#### PLANNING AND ZONING COMMISSION AGENDA - Regular Meeting

### STAFF REPORT KETCHUM PLANNING AND ZONING COMMISSION MEETING OF JANUARY 14<sup>th</sup>, 2019

**PROJECT:** Redfish Residential Live-Work Unit #201 CUP

**REQUEST:** Conditional Use Permit (CUP) for the proposed conversion of Unit #201 of the Redfish

SHEET:

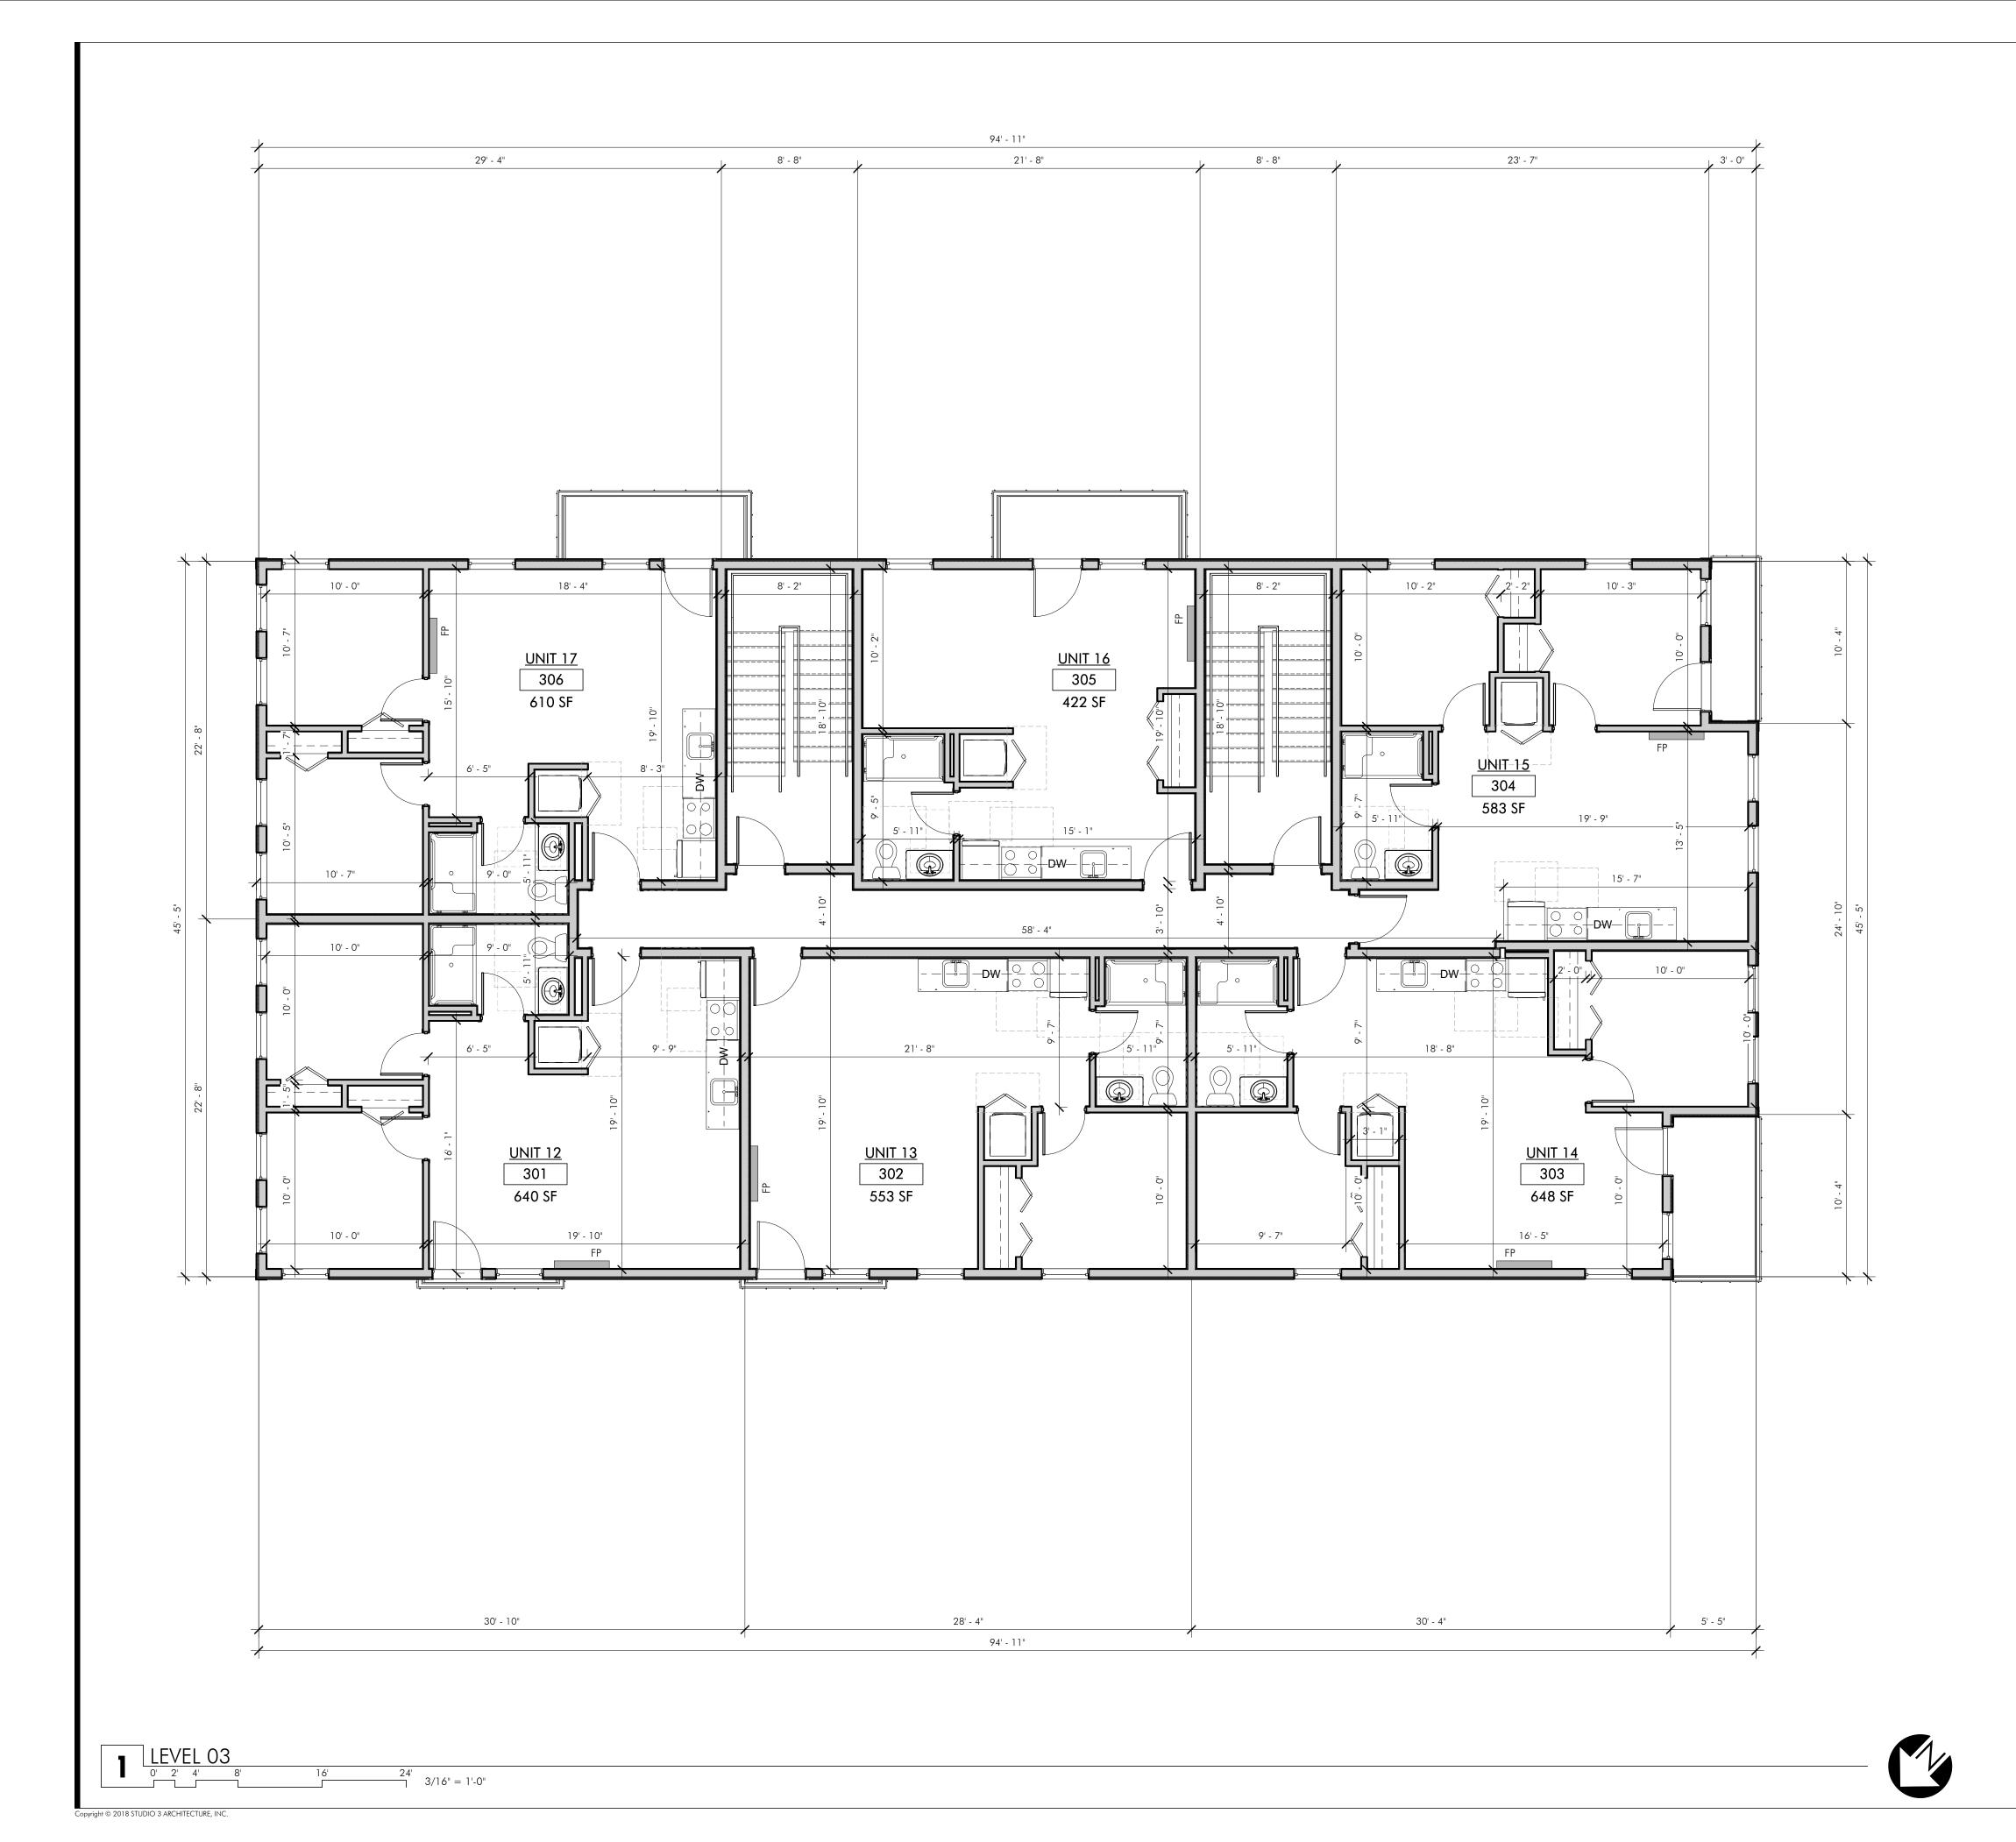
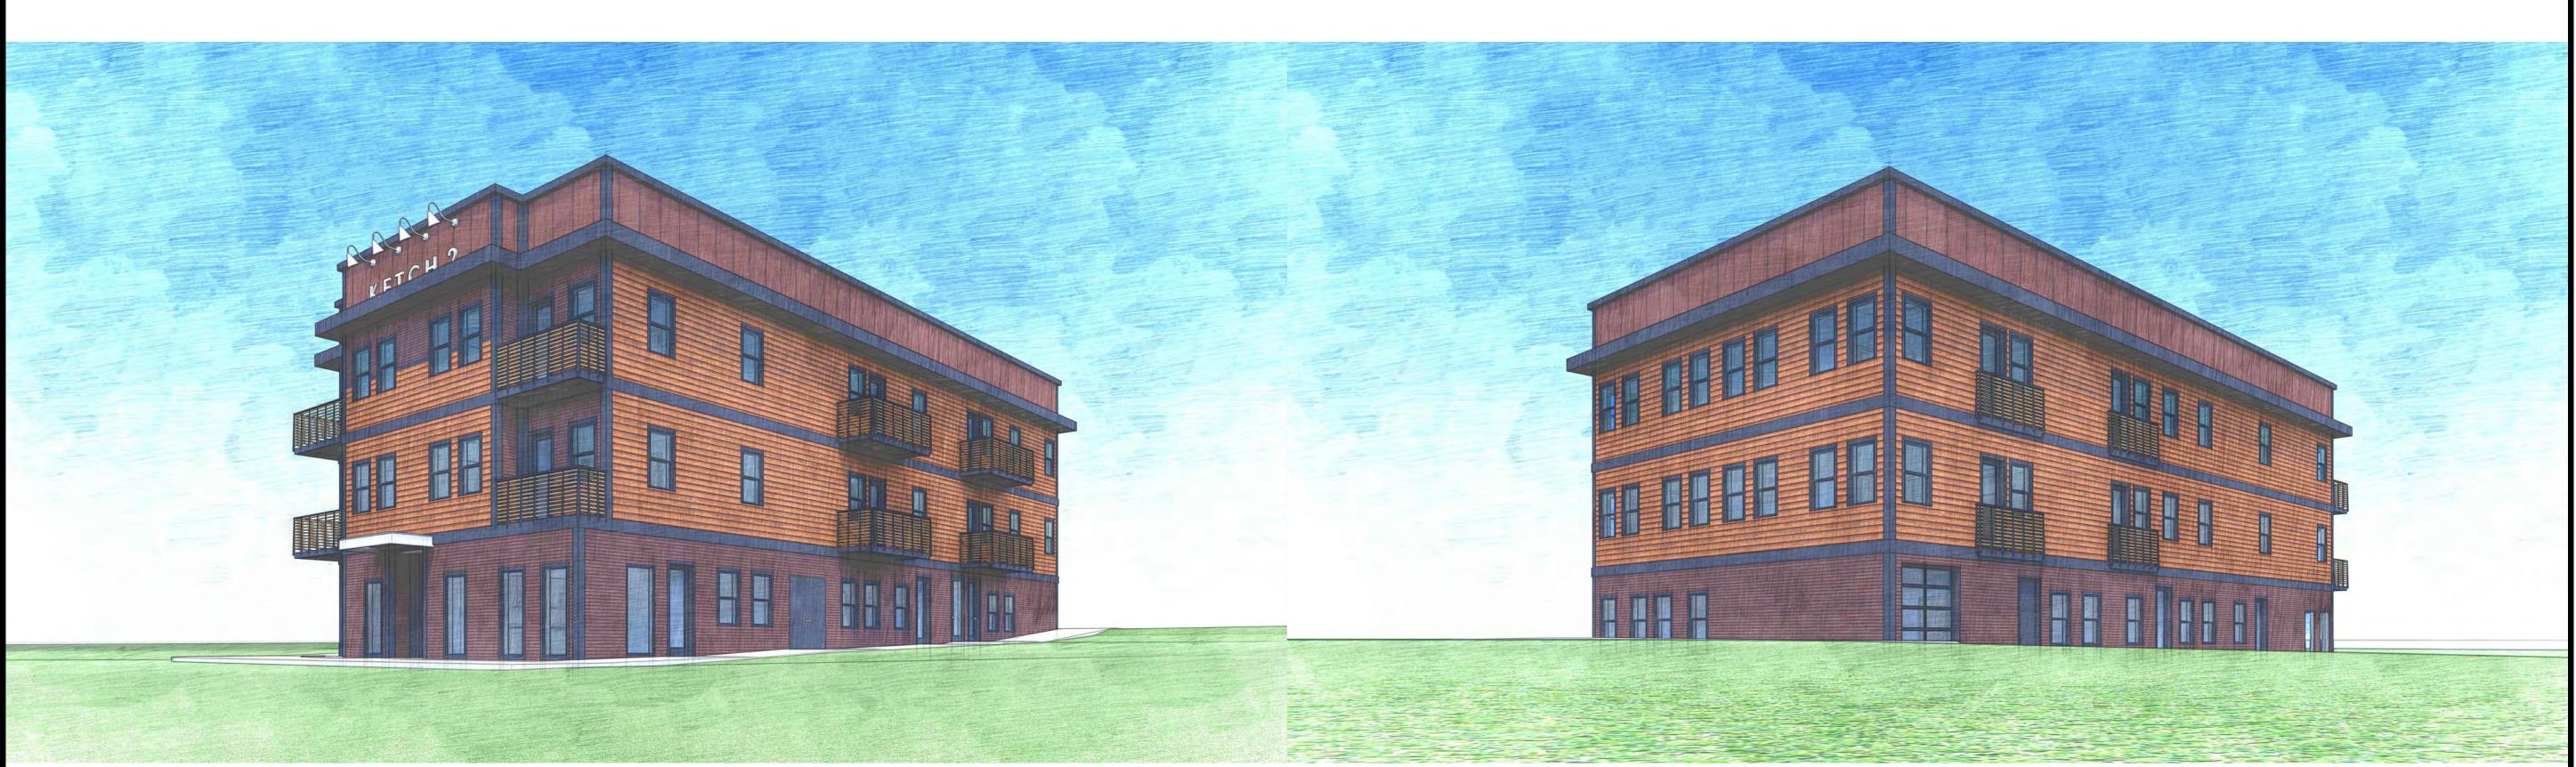
townscape, surrounding neighborhoods and adjoining structures.
			Staff Comments	The 3D color rendering sheet included in the plan set most accurately represents the
				proposed exterior colors of the project. The proposed color palette consists of medium
				to dark burgundy/chestnut brown/red hues for the siding and parapet accented by
				charcoal-colored belly band, corner, and cornice features.
				The materials consist of horizontal wood siding, 12" board and batten siding, steel-
				framed balconies and balconettes with wood slats and decking, and 18" aluminum
				lettering denoting the name of the development, "Ketch 2."
				Total Line and the development recent Zi
				These medium-to-dark earth tones are complementary to the adjacent Ketch 1
				building and other buildings in the vicinity that have muted, earth tone hues. Other
				buildings in the vicinity have facades comprised primarily of natural and composite

used on the balconies and balconettes throughout. However, the parapet wall, which
				uses horizontal battens siding and is met by a 24" deep band below, adds
				complementary height to the primary vertical mass of the building, which reduces the
				appearance of flatness.
				appearance of framess.
				Additionally, the substantial amount of glazing for the windows and doors, along with
				the balconies and balconettes, punctuate the mass of the building – reducing the
				appearance of bulk - and provide visual interest.
$\boxtimes$			17.96.060(F)(3)	There shall be continuity of materials, colors and signing within the project.
			Staff Comments	The same materials and color schemes are used on all four facades of the building.
	$\boxtimes$		17.96.060(F)(4)	Accessory structures, fences, walls and landscape features within the project shall
				match or complement the principal building.
			Staff Comments	Accessory structures, fences, and walls have not been proposed and are not required.

Staff Comments	For properties located on a corner the shortest lot line is considered the front, or
				primary frontage. In this case the primary street frontage is 1 <sup>st</sup> Avenue and the
				building orients toward it; the main entrance as well as the building signage are
				located on the 1 <sup>st</sup> Avenue side of the building.
$\boxtimes$			17.96.060(F)(7)	Garbage storage areas and satellite receivers shall be screened from public view and
				located off alleys.
			Staff Comments	The first-floor plan and the rendering sheet indicate that the garbage storage area will
				be enclosed within the building. No satellite receivers are proposed.

Self Comments   There is one accessory retail space, 402 square feet in size, proposed at the corner of 6"Street and 25t Avenue. The elevations and enderings indicate a glass strong from windows of the same dimension as the entry door. For nonresidential portions of buildings, front facades shall be designed to not obscure views into windows.    Self Comments   The nonresidential portion of the building has been designed with ample windows and a glass door in order to provide views into the commercial space.   Roofing forms and materials shall be compatible with the overall style and character of the structure. Reflective materials are prohibited.    Staff Comments   The form of the roof) is of fact roof. The roofine is defined by a 6" high parapet wall that is visually separated from the third story by a prominent belt band that has a 24" overhang. The color of the roof is the same color as the ground floor wood siding and the bond is the same color of the roof is the same color as the ground floor wood siding on the bond is the same color of the building façade. No reflective materials are proposed.   All pitcher forofs shall be designed to sufficiently hold all snow with snow clips, gutters, and downspouts.		1	1
